TEXAS DEPARTMENT OF TRANSPORTATION

MINOR DESIGN UPDATES UNDER CONSIDERATION FOR FINAL DESIGN

CROSS STREET IMPROVEMENTS

Old Mill Road

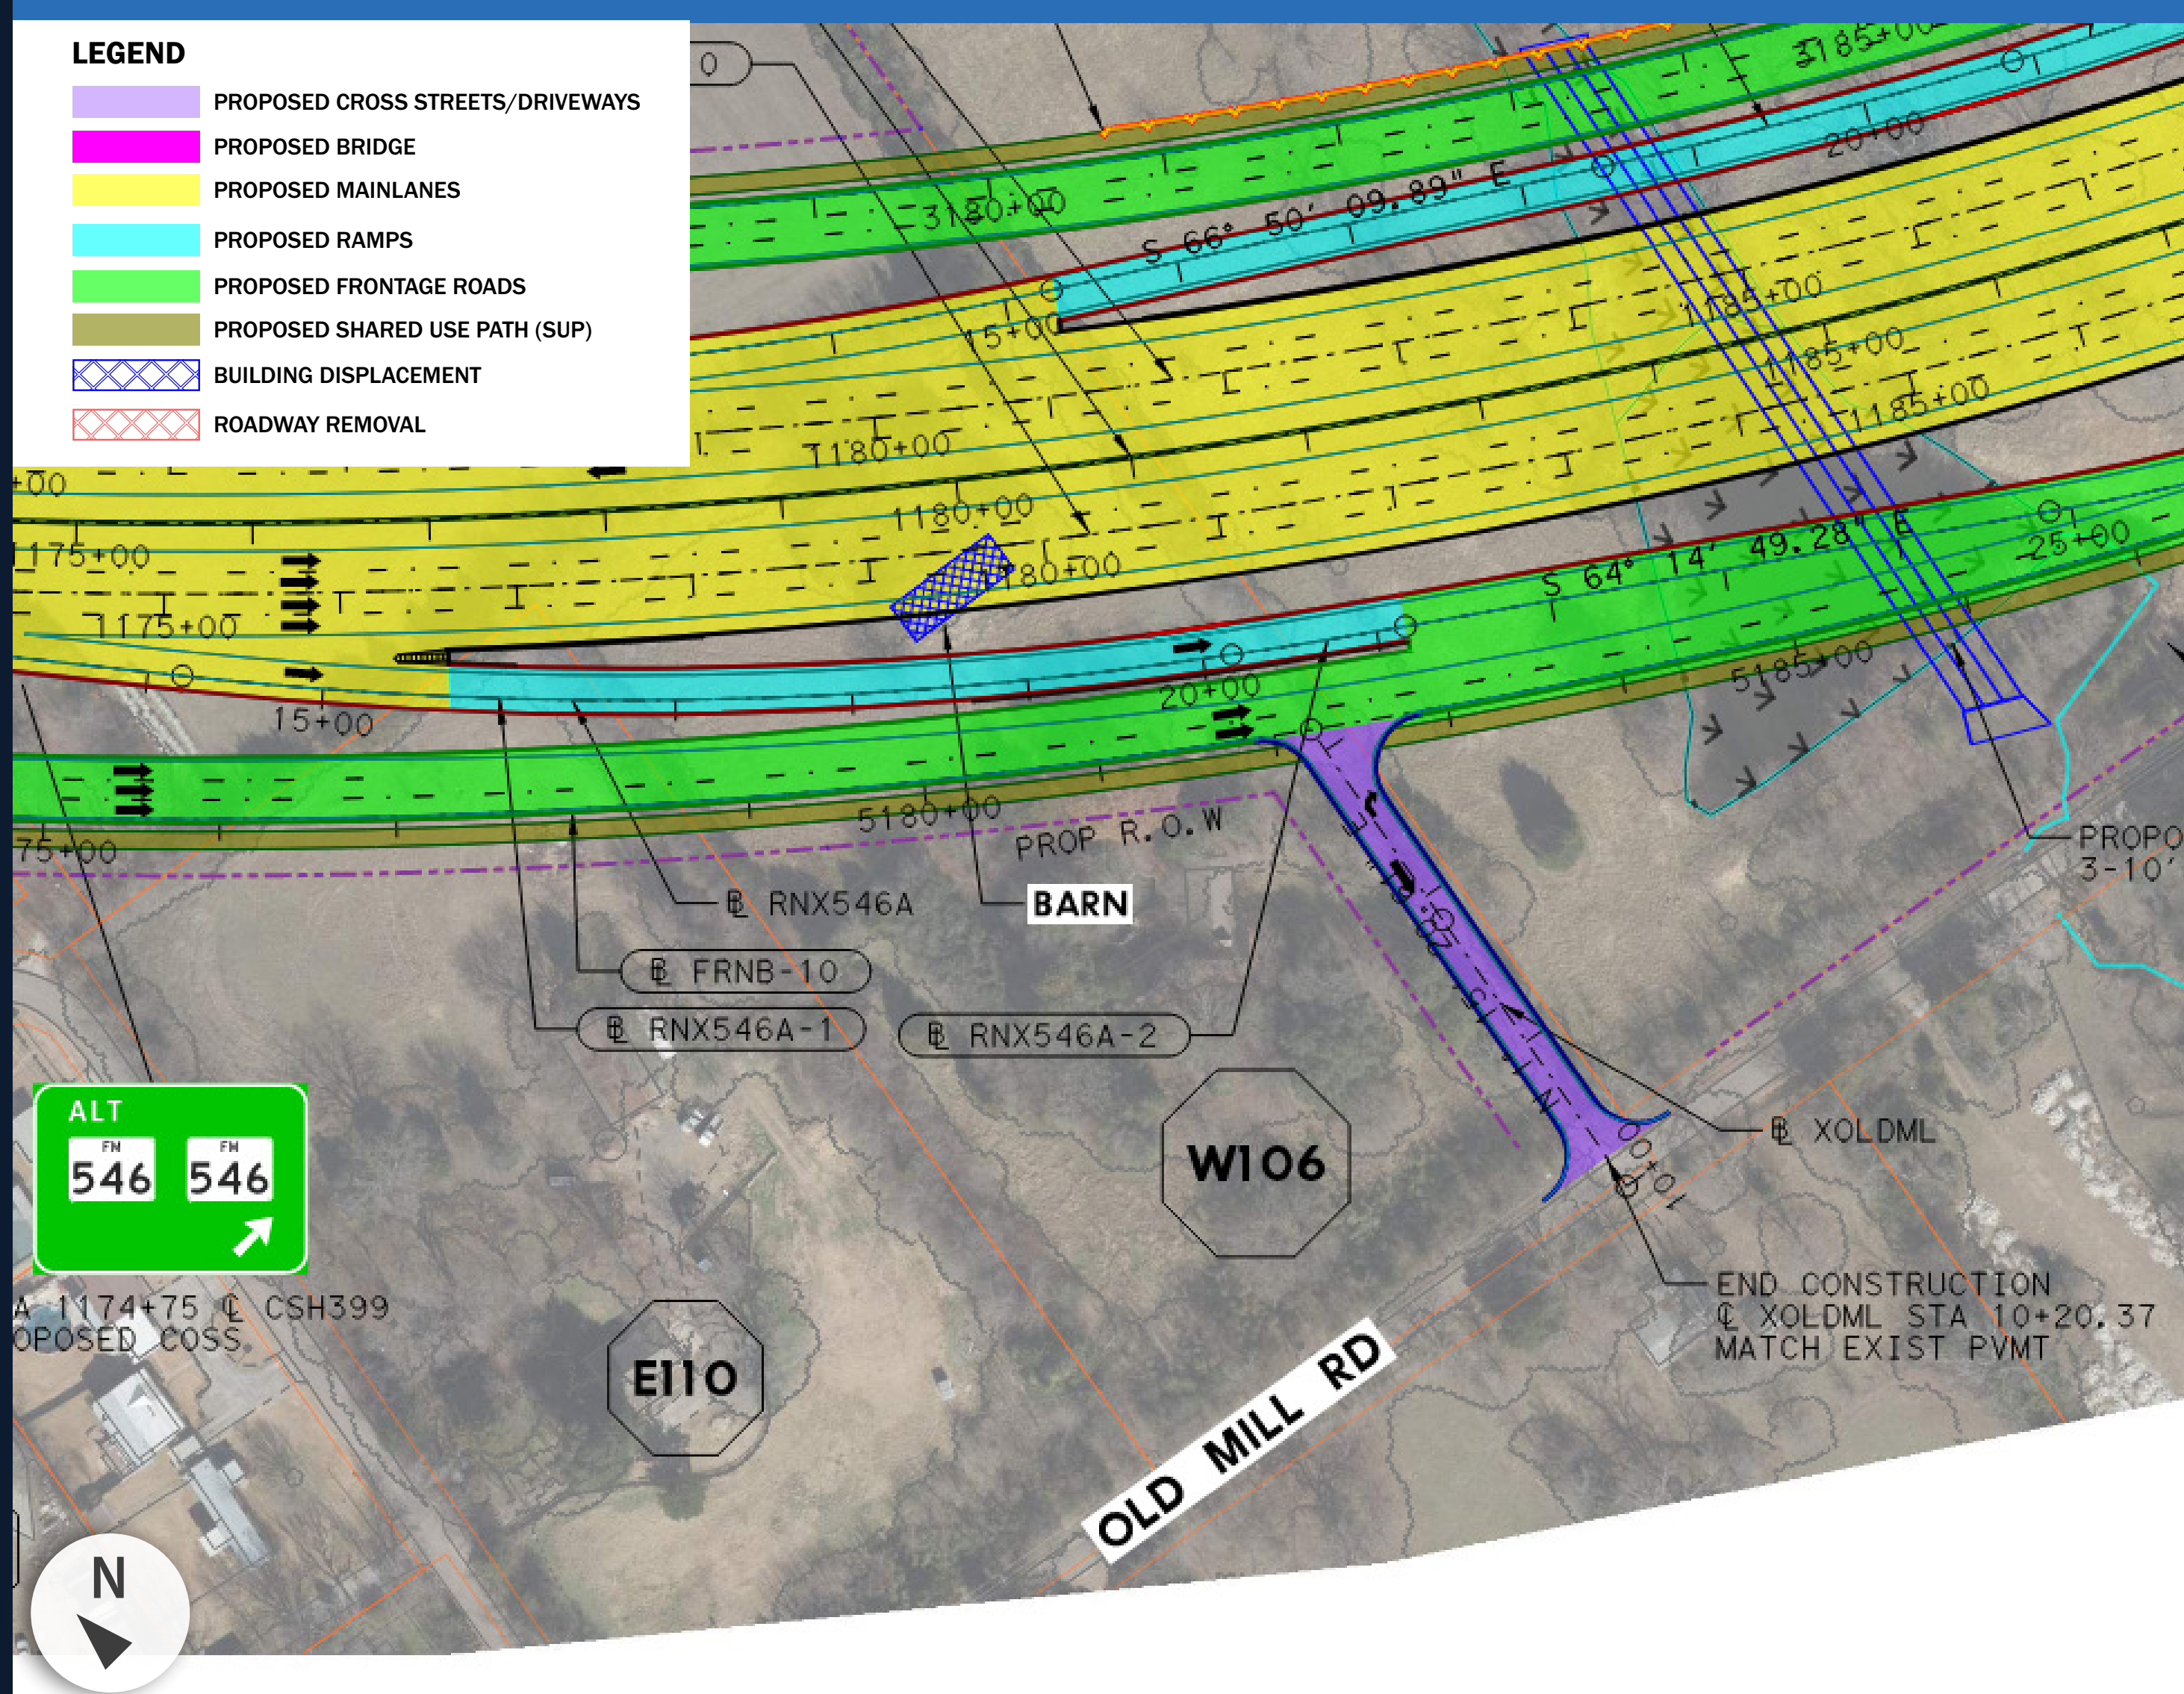
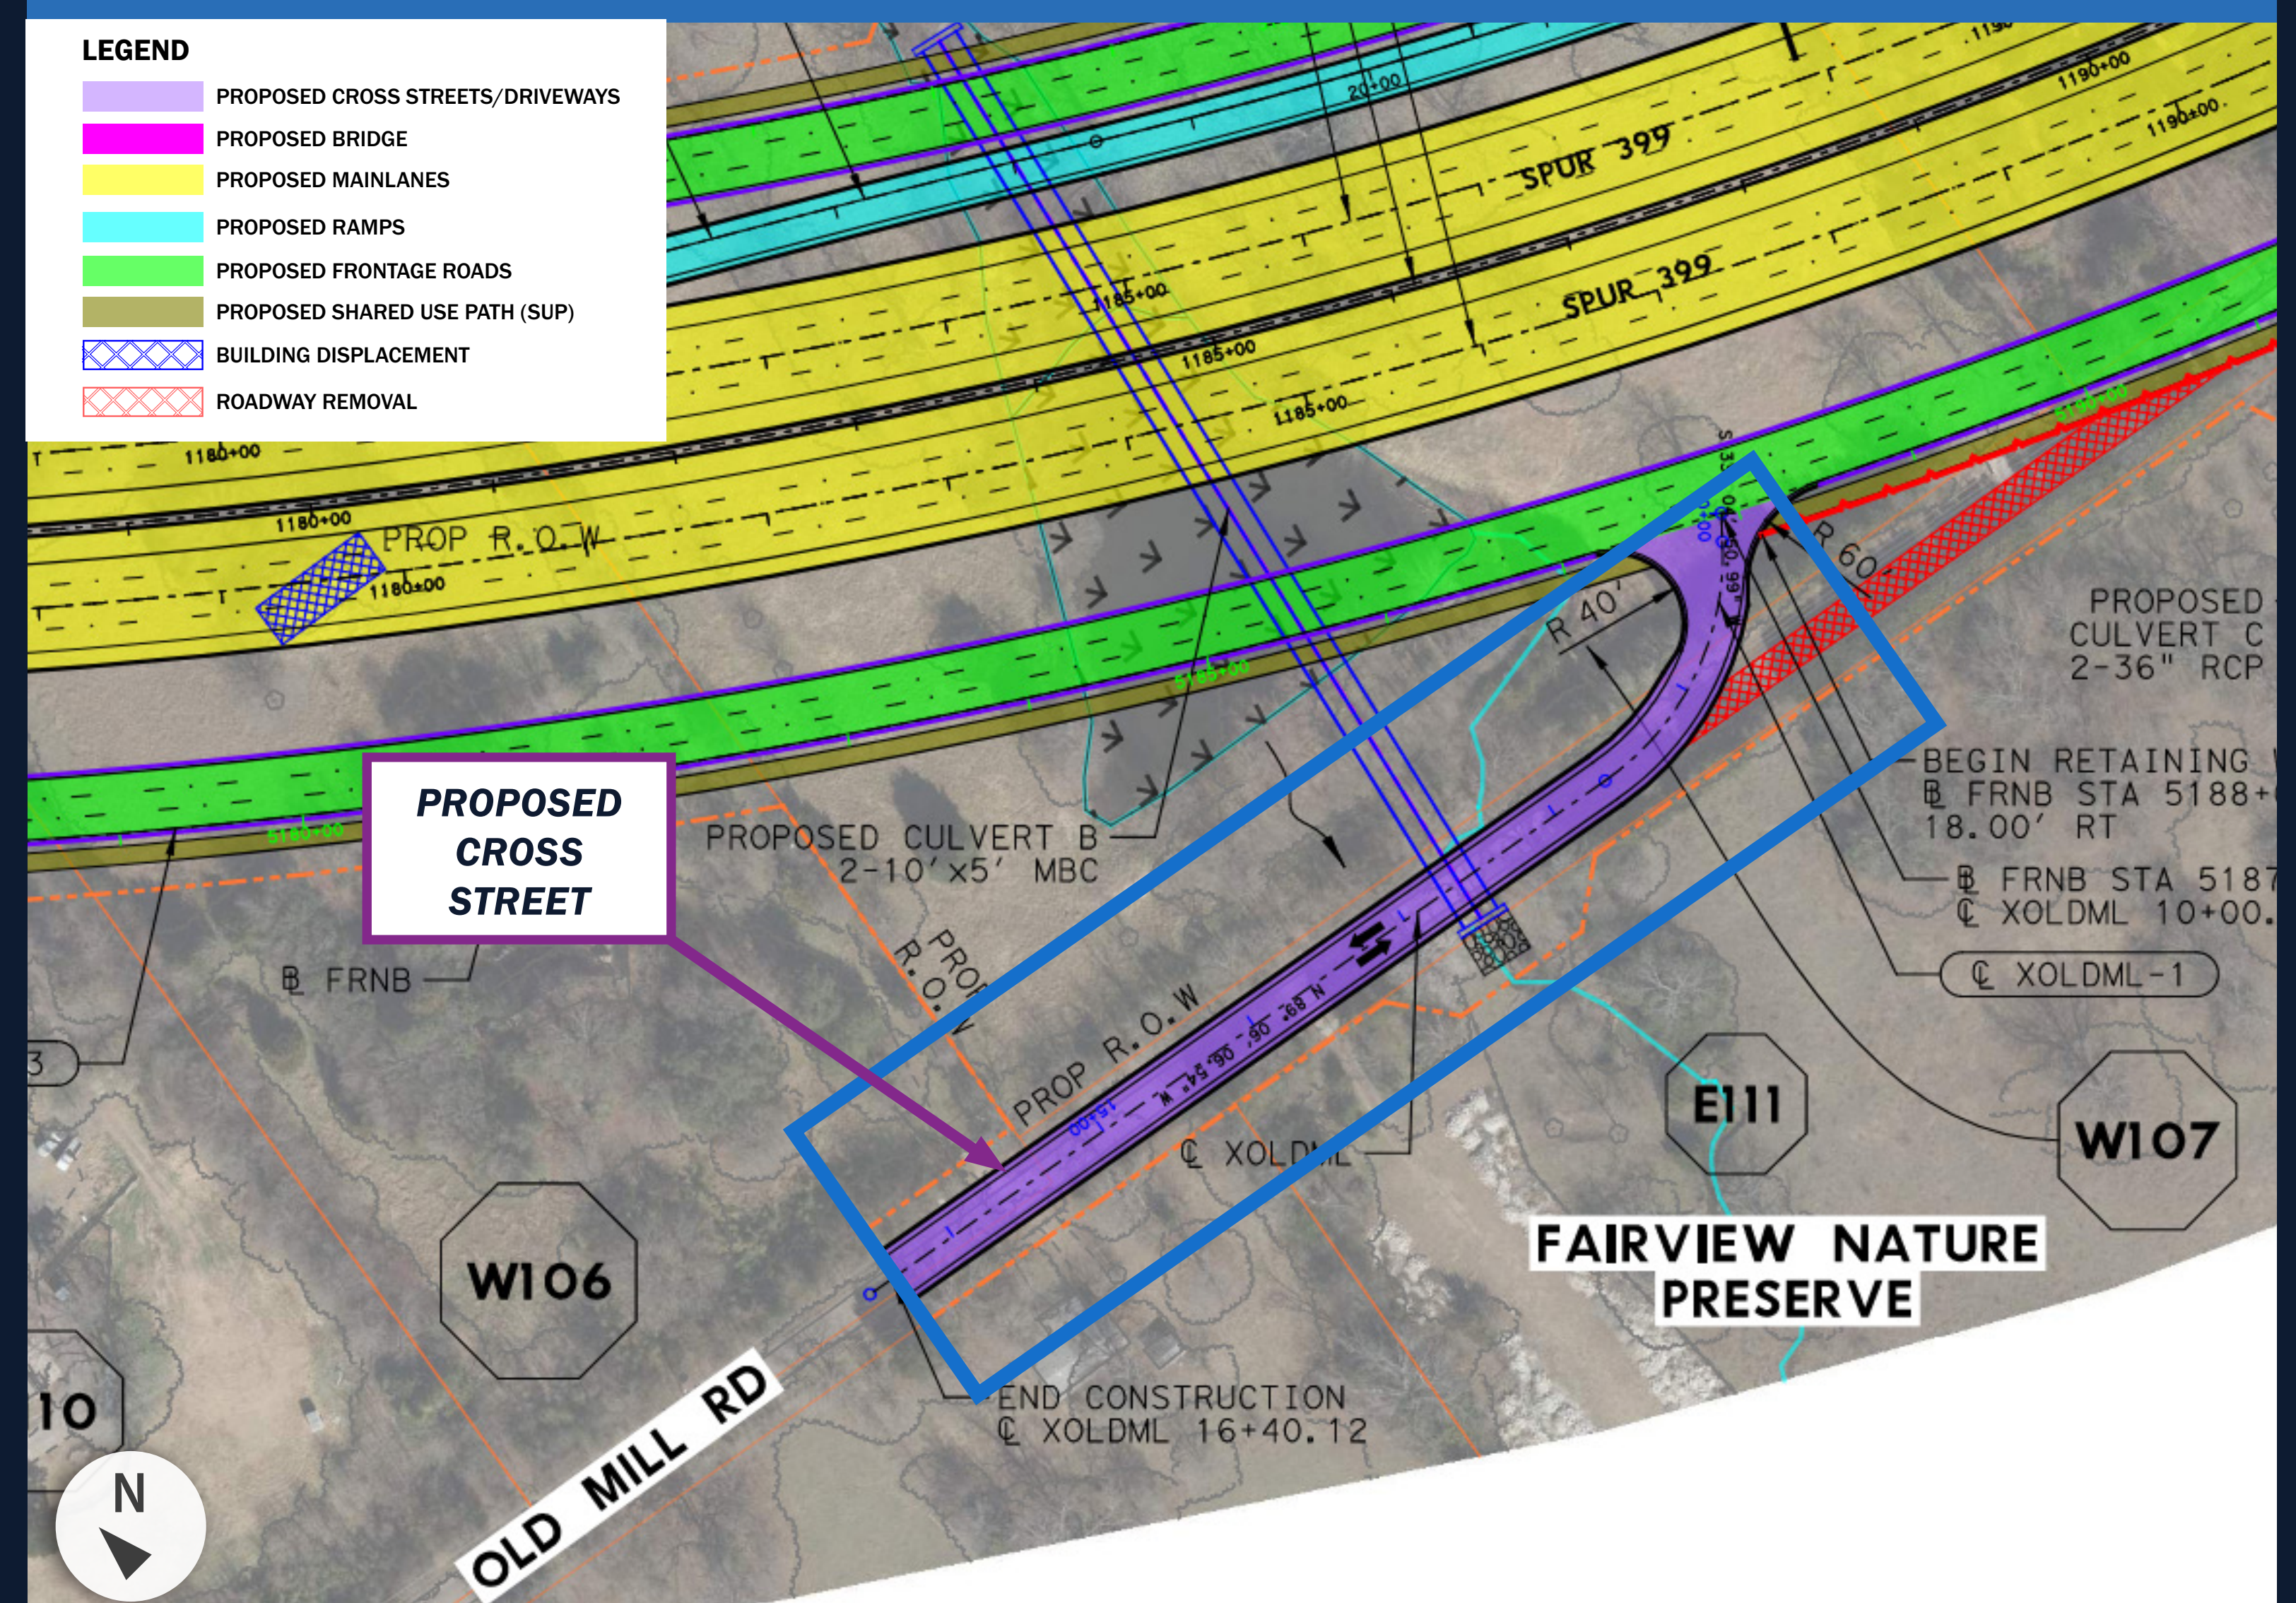
The Old Mill road connection would be moved further to the south so drivers exiting the northbound ramp have more weaving distance. The proposed cross street at Old Mill Drive also provides access to Fairview Nature Preserve.
